TRACT B, PEACEFUL RIDGE AT FOUNTAIN VALLEY
EL PASO COUNTY, COLORADO

RETAINING WALL SHOP DRAWINGS

Architectural-Structural Plans.pdf Markup Summary

Project Name:	TRACT B, PEACEFUL RIDGE AT FOUNTAIN VALLEY EL PASO COUNTY, COLORADO
Sheet Title:	RETAINING WALL SITE PLAN

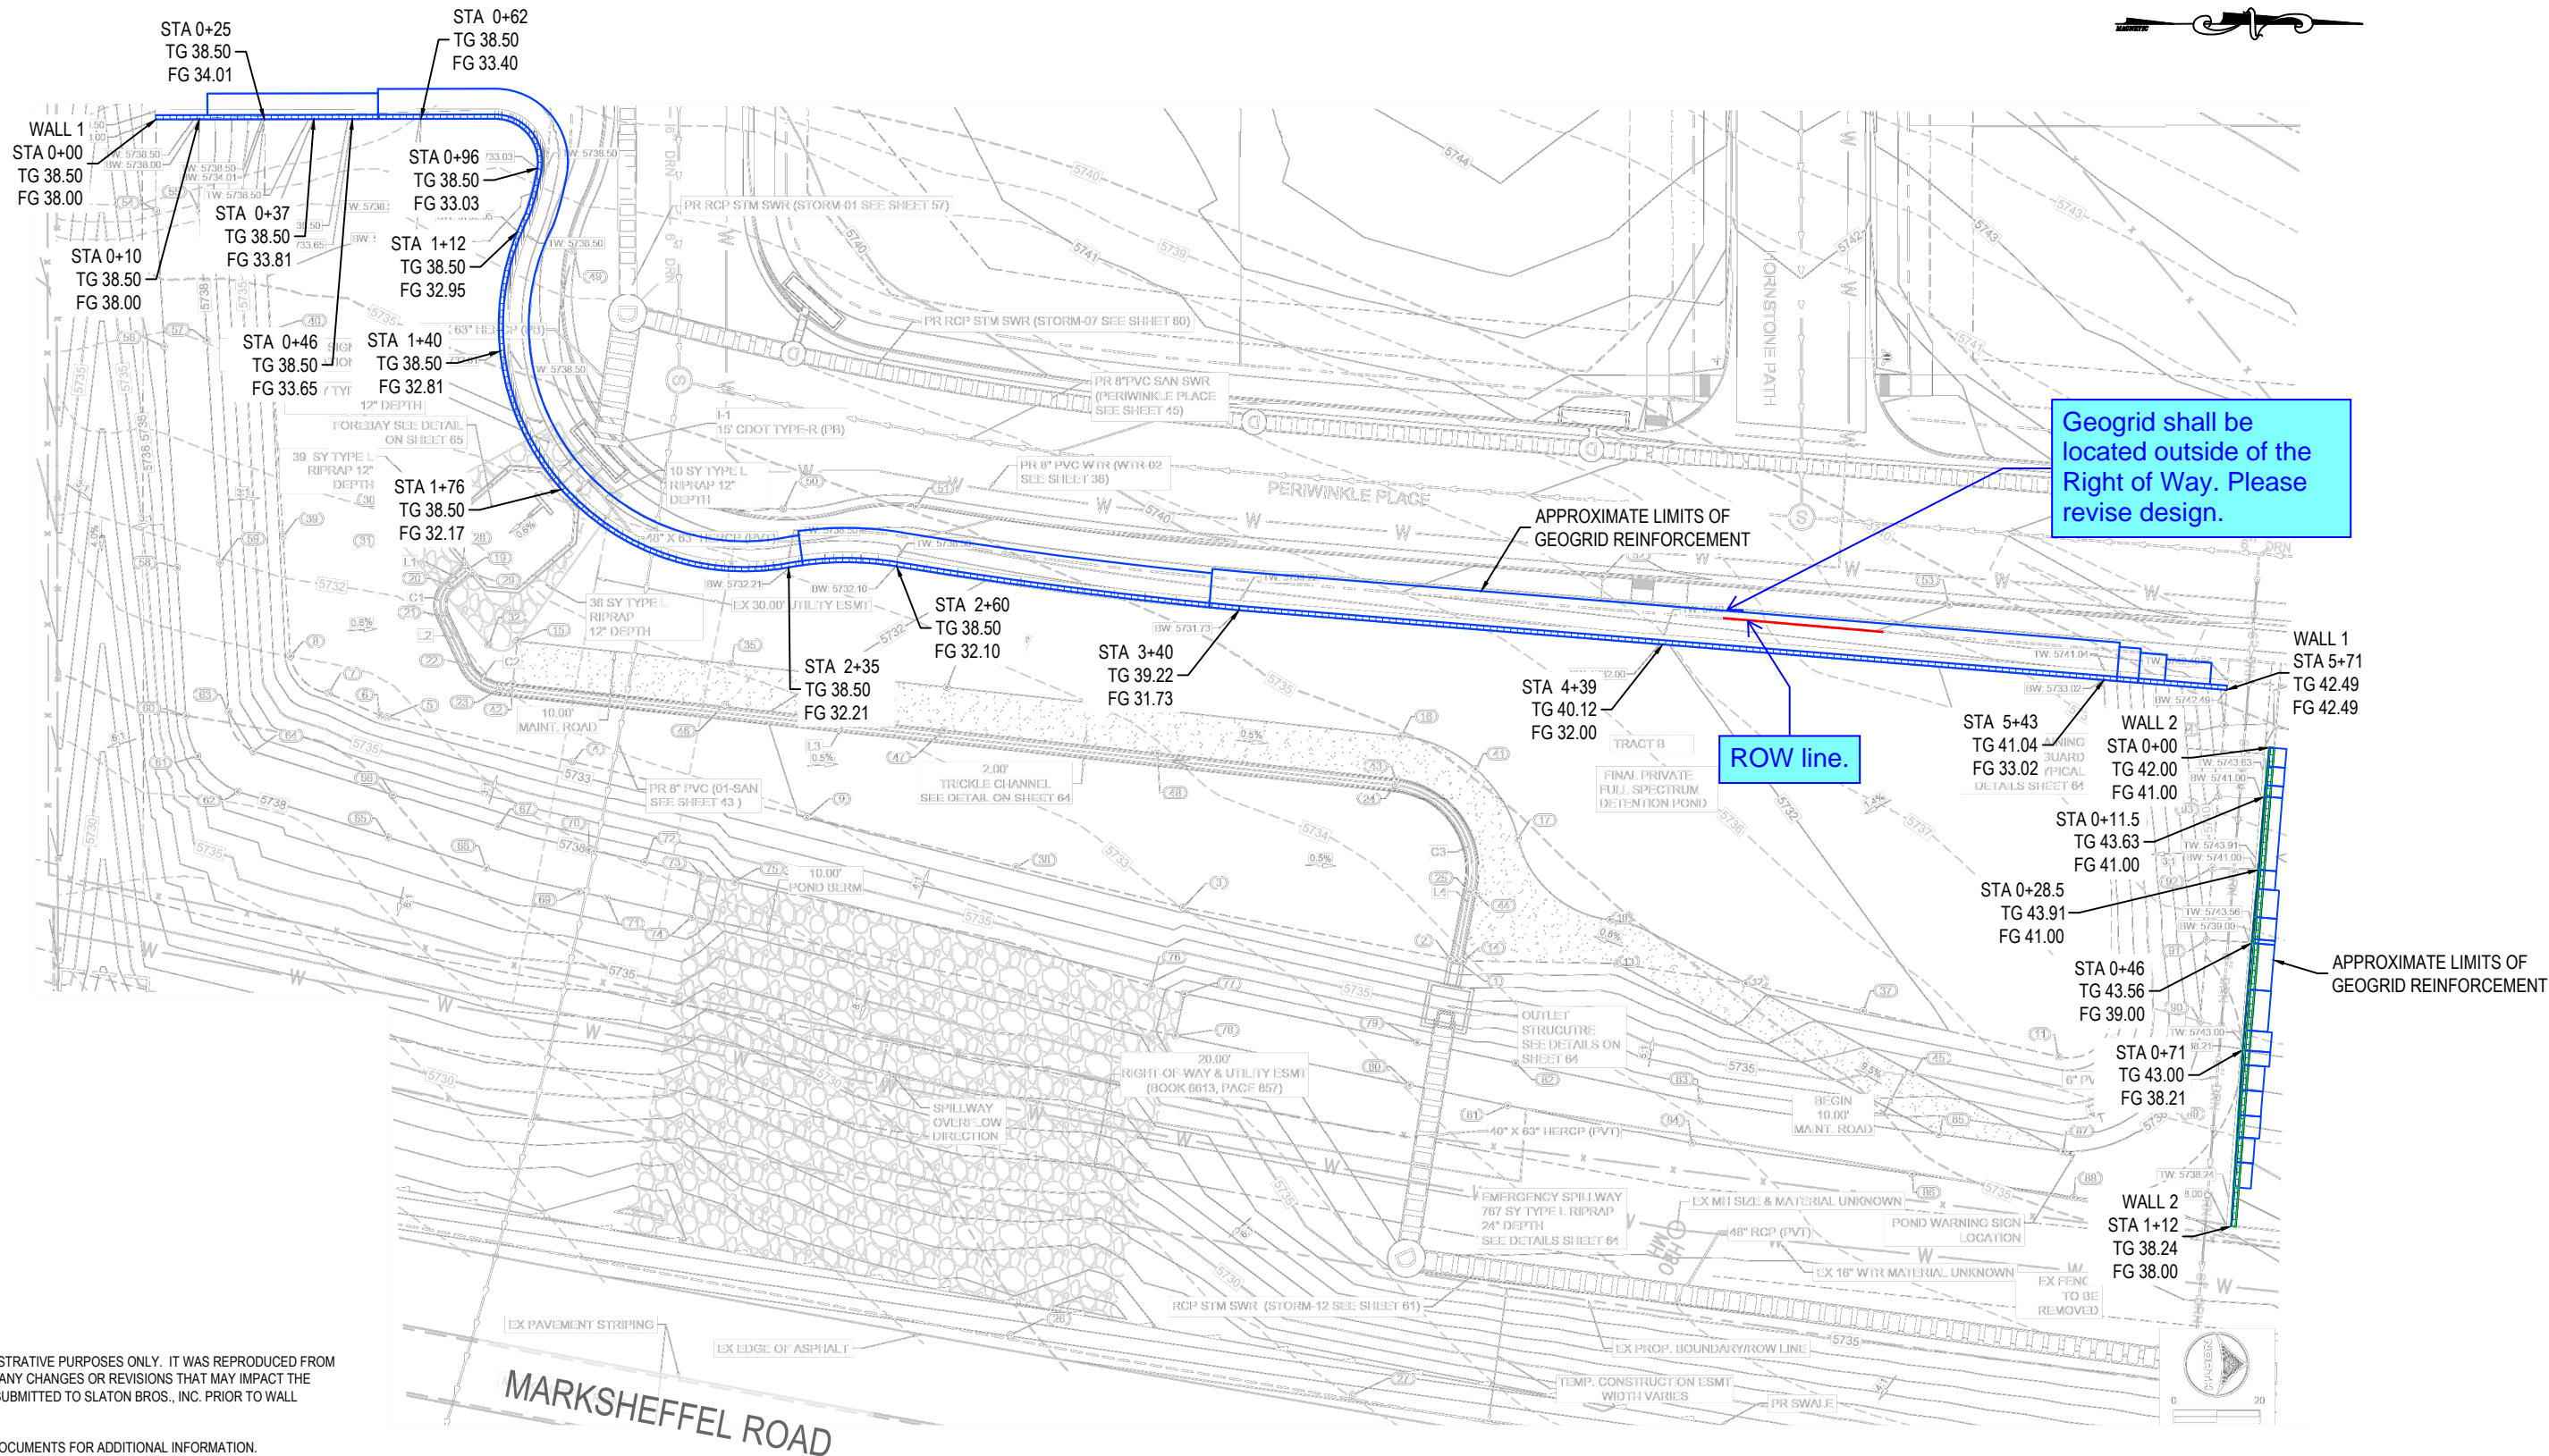
Geogrid shall be located outside of the Right of Way. Please revise design.

ROW line.
